# 1984 Corvette: Recall: Rear Axle Differential Cross Shaft Retention

**Subject:** REAR AXLE DIFFERENTIAL CROSS SHAFT RETENTION

**Model and Year:** 1984 CHEVROLET CORVETTE MODELS

**Bulletin Number:** 84-C-25 - (09/20/1985)

FIGURE 1

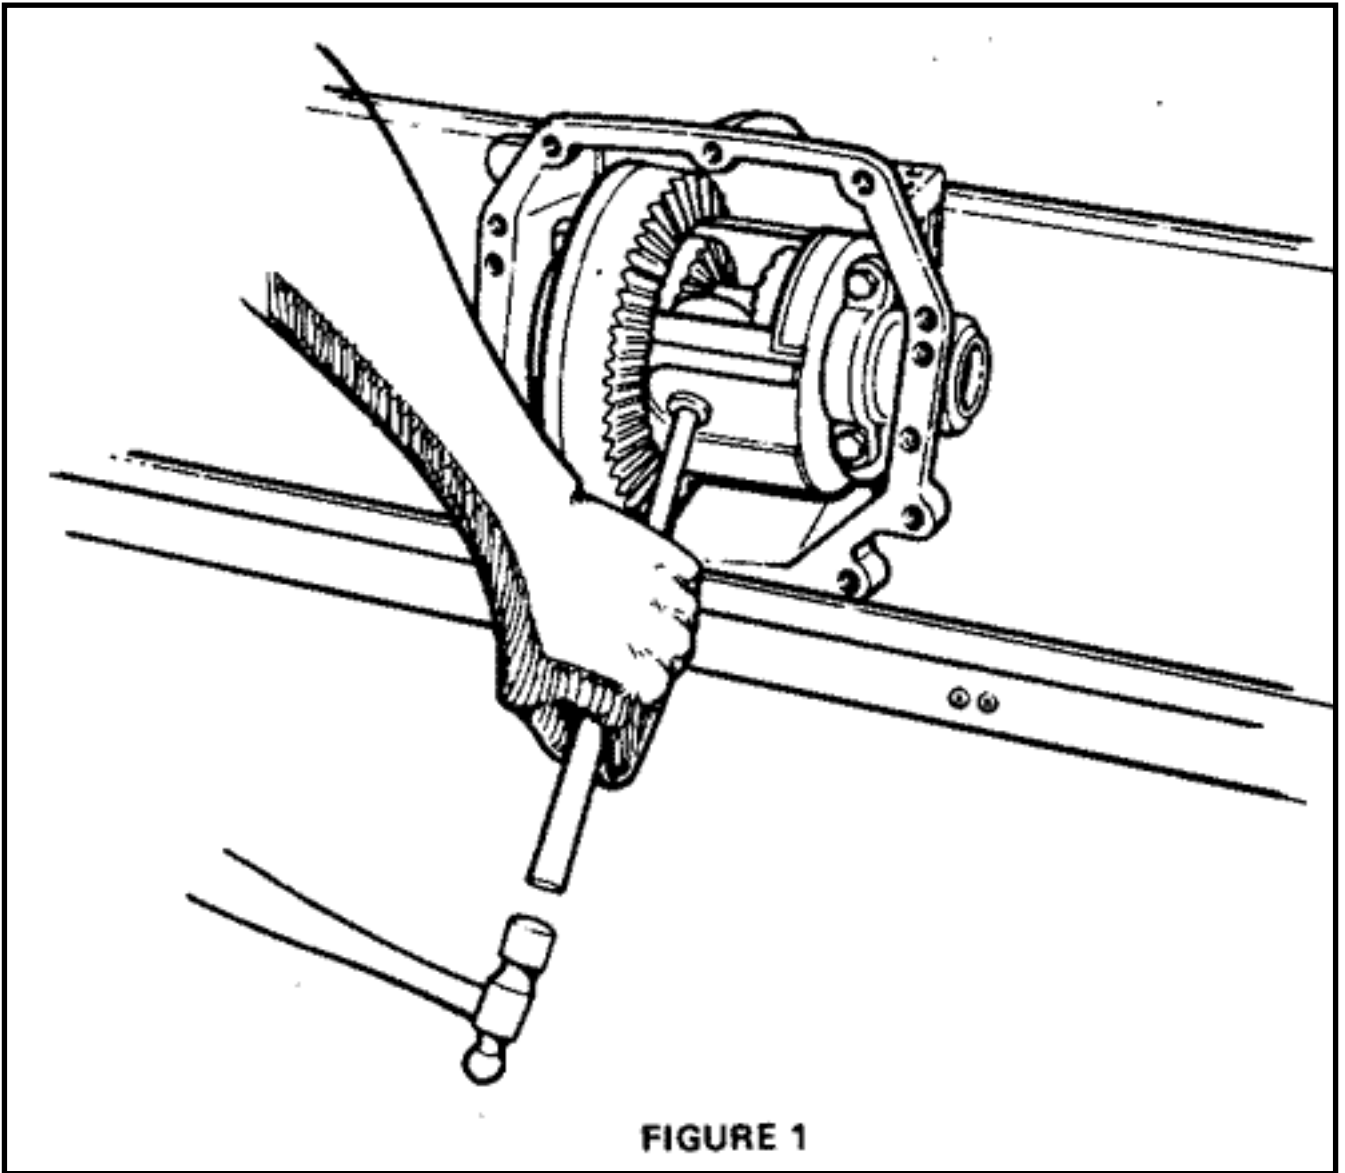
5. Rotate case assembly to position illustrated in Figure 1. With appropriate size drift and small mallet, lightly tap on cross shaft to determine if movement of shaft can be achieved.

**FIGURE 2**

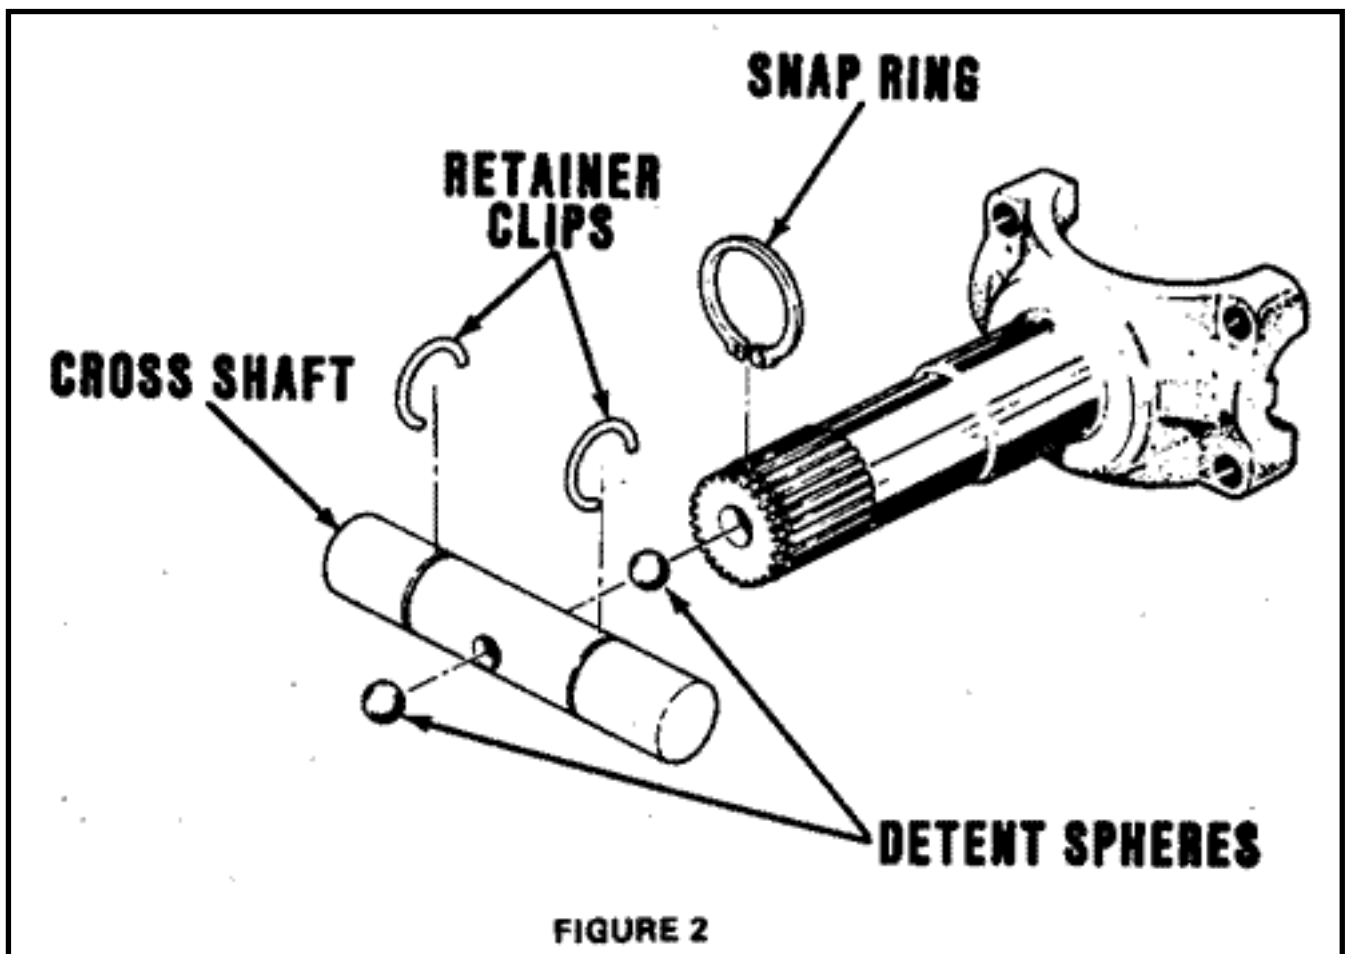
Tap cross shaft inboard approximately 1 1/4 inches and rotate case 180 DEG. Utilizing vise grips and a back and forth motion, remove shaft. Install new cross shaft insuring detents in the shaft are positioned properly to accept spheres (balls) to be installed, between shaft and output yokes as illustrated in Figure 2.

Remove case assembly from carrier following appropriate procedure in 1985 Corvette Shop Manual. Press existing cross shaft out of case and install new cross shaft insuring detents in the shaft are positioned properly to accept spheres (balls) to be installed between shaft and output yokes as illustrated in
